Notice of Allowability

10/780,171

LIN ET AL.

DETAILED ACTION

FIG. 1A
(PRIOR ART)

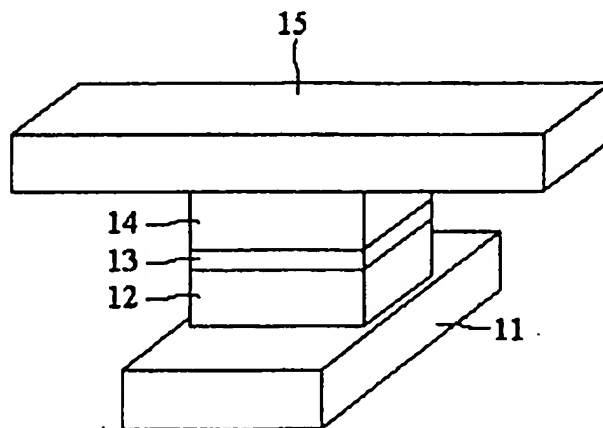
5. The proposed drawings corrections (Fig. 1A, 1B, 1C, 2A, 2B, and 3) received on January 30, 2006 are approved by Examiner.

APPROVED
2-8-2006
AGS
